**Albertson Engineering Inc.**

RE: Masonic Lodge Roof Repairs – Phase 1  
Structural Recommendations  
Albertson Engineering File #2021-060

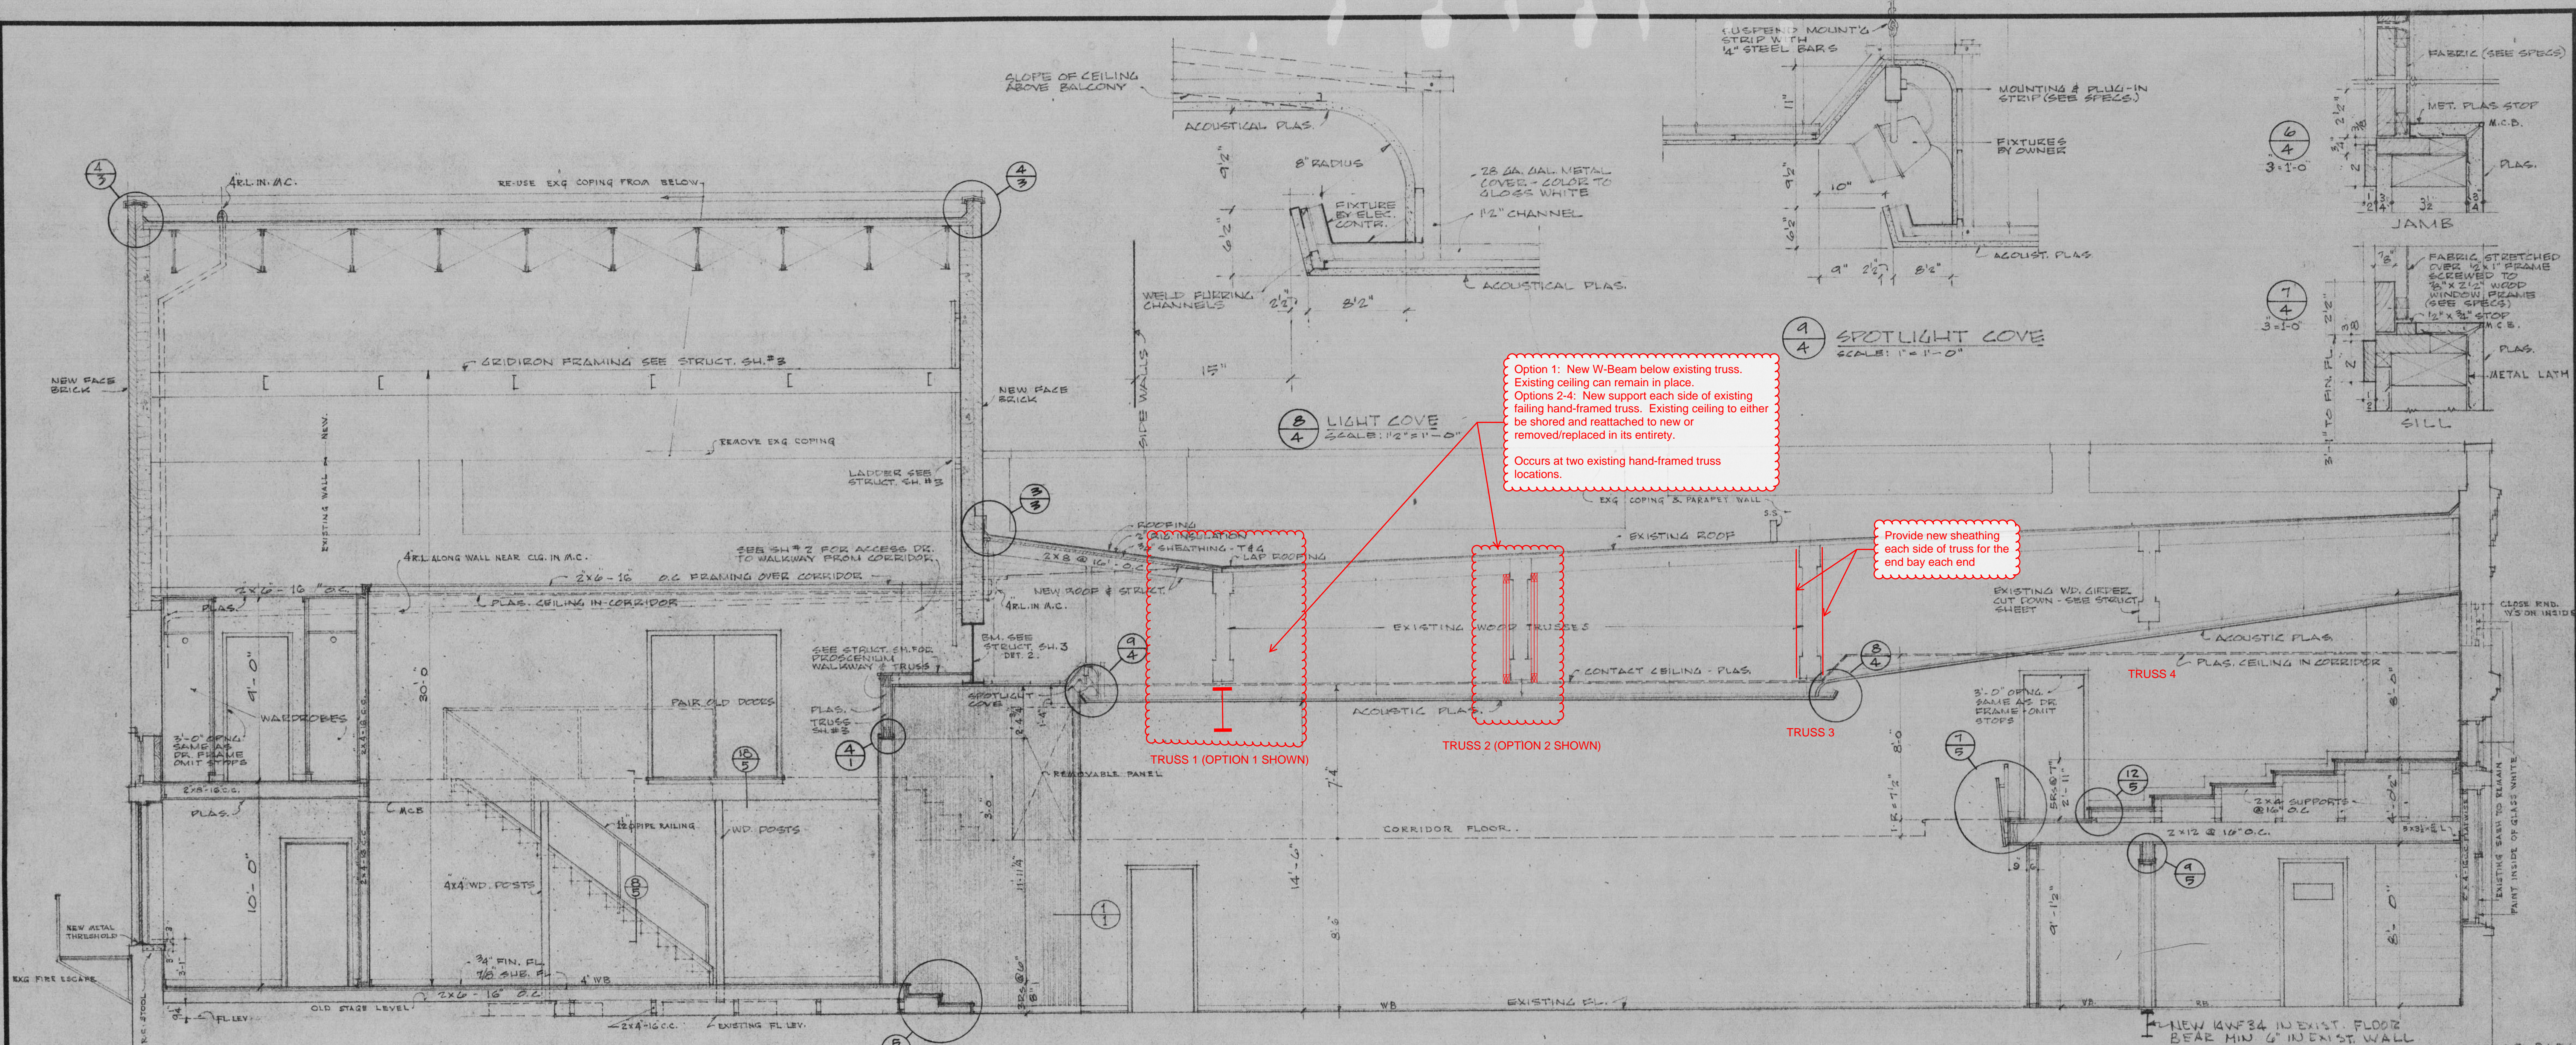
To supplement these recommendations, we have provided redline mark-ups on an existing building section from the plans dated 1959. This, in addition to the repair drawings for the various options that were previously referenced, should help to firm up both repair costs as well as a timeline for completing the repairs. We are prepared to move into Phase 2 services and provide final construction drawings once you have determined which repair option you and the Owner would like to proceed with.

OPTION 1 - STEEL W-BEAM

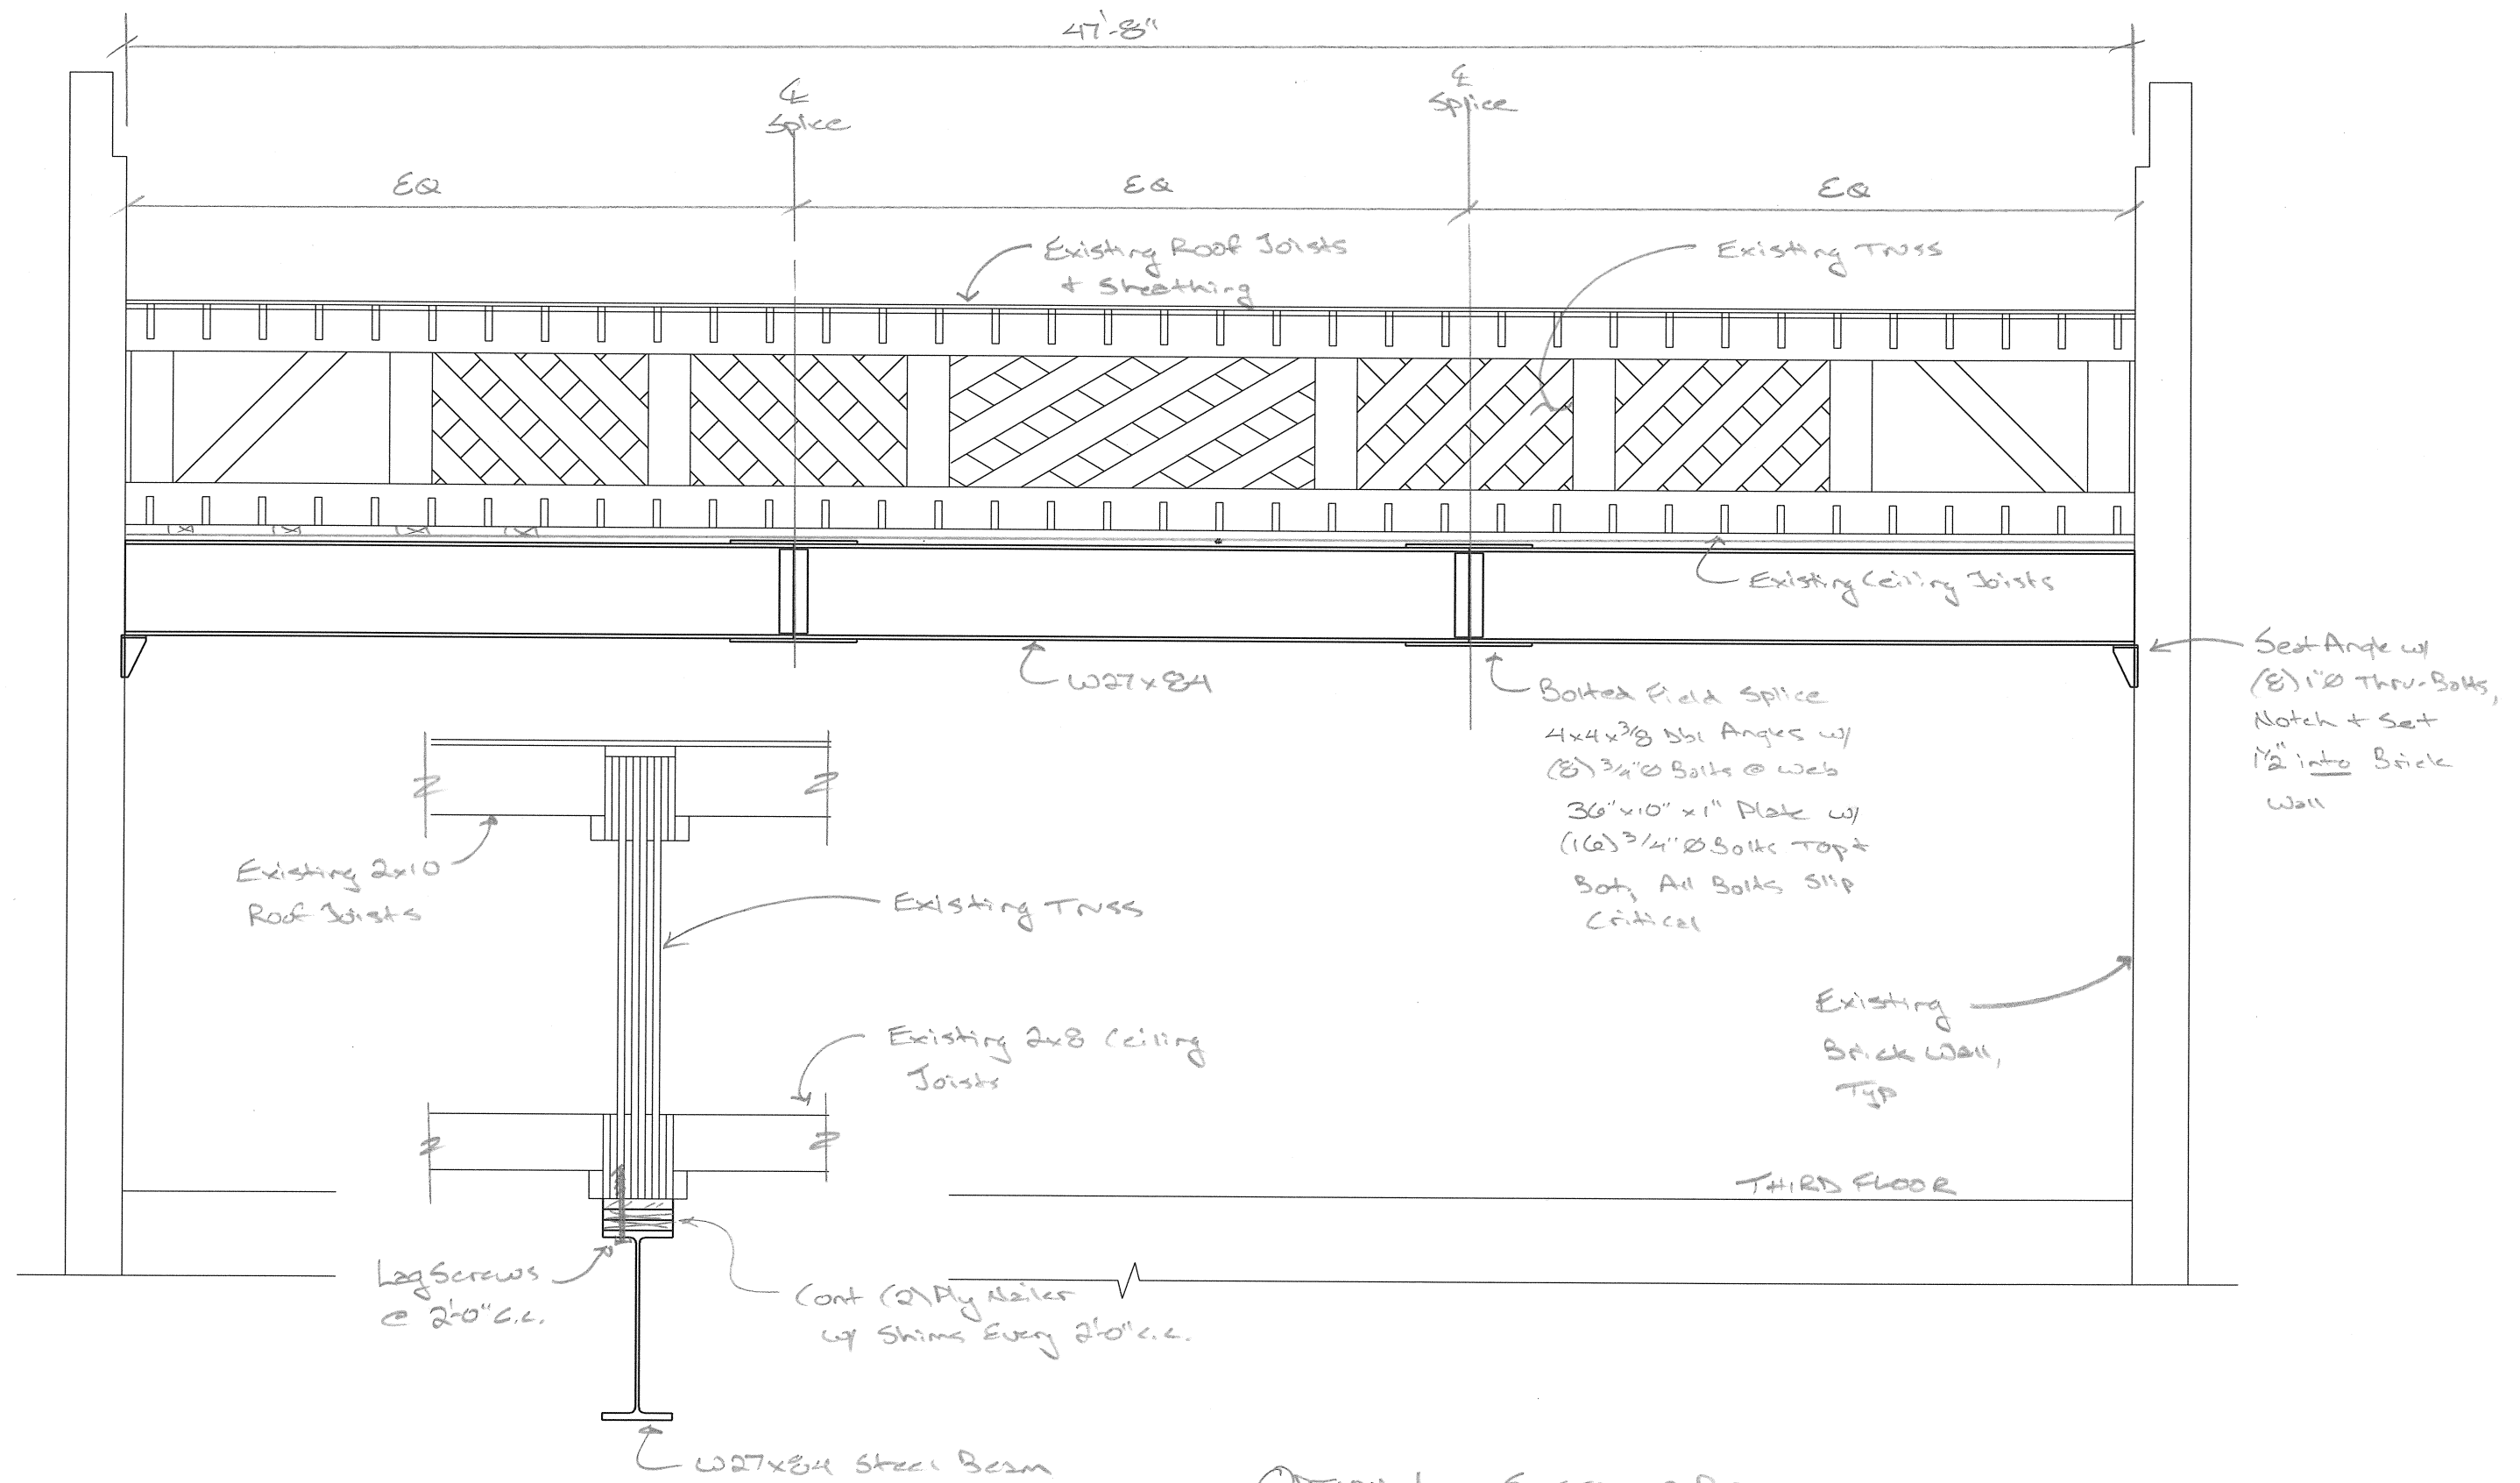
- Option 1 – W-Beam: Provide a new W27x84 steel beam below the existing wood trusses.

- Beam to be spliced at roughly third-points using bolted field splice connections. Field splices will require slip critical connections with direct tension washers or equal to verify the bolts have been pretensioned.

- Beams to be supported at each end on the existing brick wall with a seat angle assembly that will be notched slightly into the existing wall for bearing, with pull-out resisted by providing thru-bolts that will pass through the entire brick wall. Exterior plate washers and nuts will remain exposed on the exterior face of wall.

- Beams are to be set slightly below the existing truss with 2x nailers pre-attached to the steel beam. Wood blocking spacers/shims will then be provided at roughly 2'-0" on center to engage the existing truss.

- Both roof and ceiling framing can remain largely in-place during repairs, with a new soffit framed around the new beam as required to aesthetically cover the framing.

OPTION 2 - P/E WOOD TRUSS  
 1/4" = 1'-0"

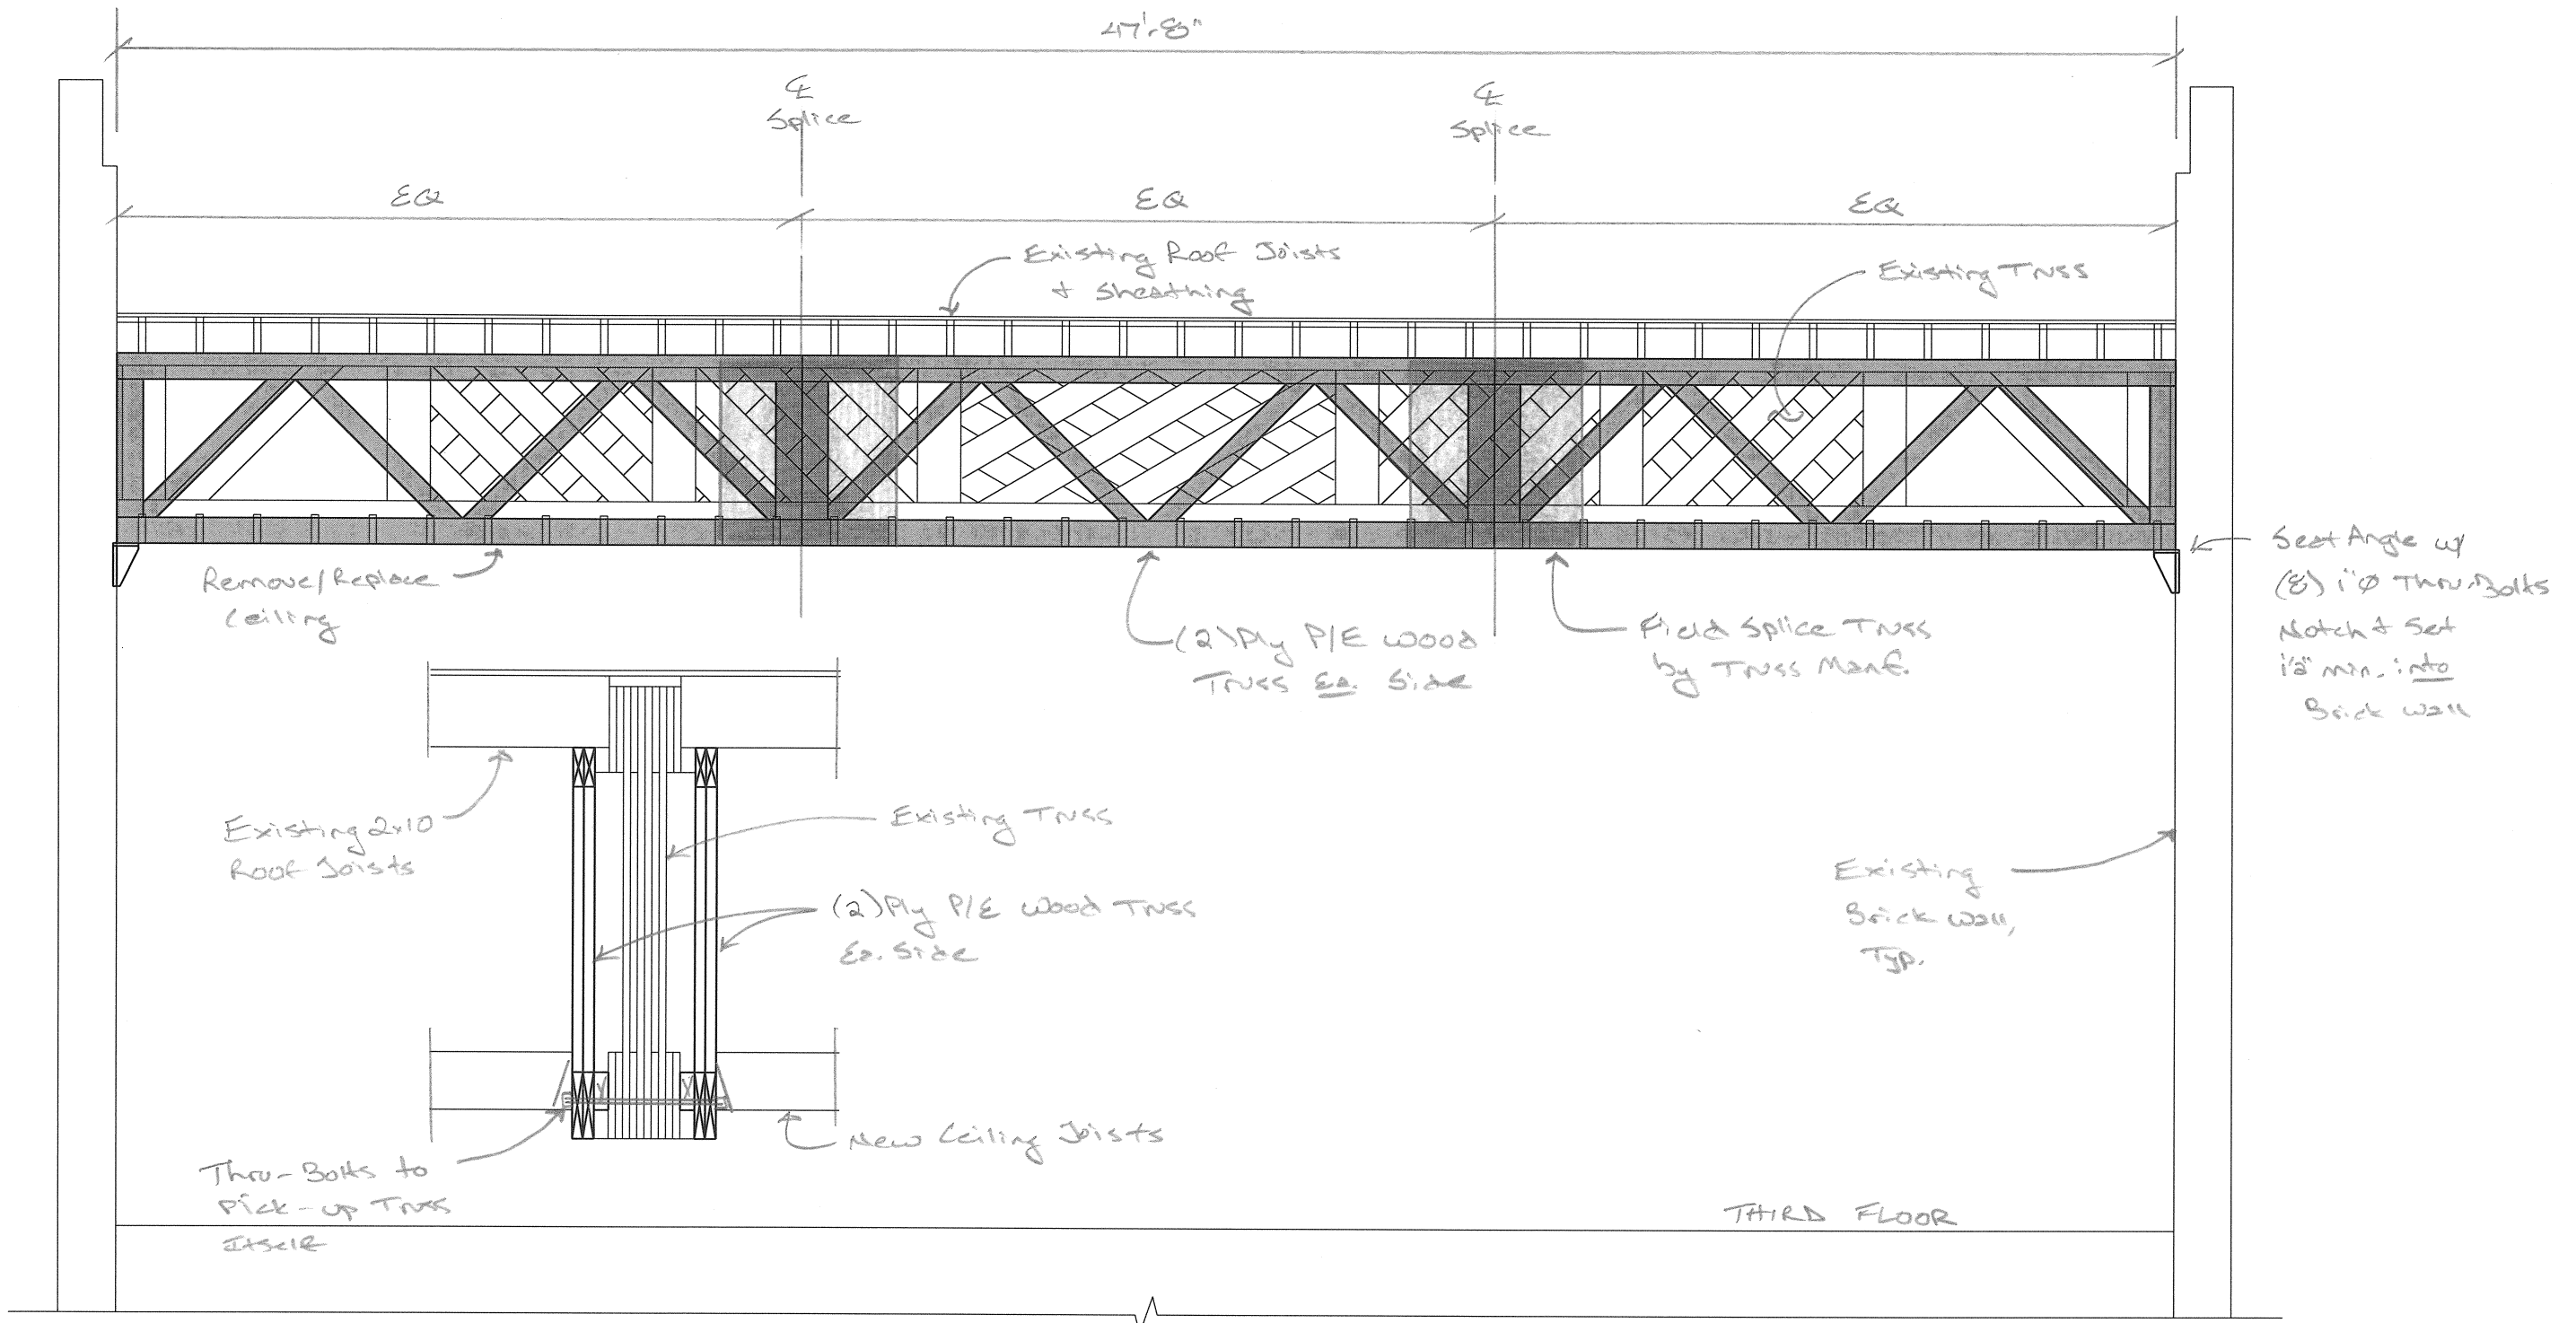
- Option 2 – P/E Wood Girder Trusses: Provide a new (2) ply girder truss on each side of the existing roof truss.
    - Girder truss depth to be field verified to match the depth from bottom of roof joists to bottom of existing wood truss.

- Girder trusses to be field spliced at roughly the third points. All field splicing to be done from one side only, with field splice designed by the truss manufacturer.

- Ceiling framing to either be shored and then suspended from the new girder truss or alternately removed and replaced in its entirety.
    - Blocking and thru-bolts to be provided at the bottom of the truss to engage and carry the existing truss.

- Trusses will need to be supported each end with a seat angle assembly similar to that described for the steel beam option.
    - Please note that we have been working directly with Black Hills Truss & Components and have verified that this is a viable repair option. Please contact Tom Watson at their office here in Rapid City for additional information if needed.
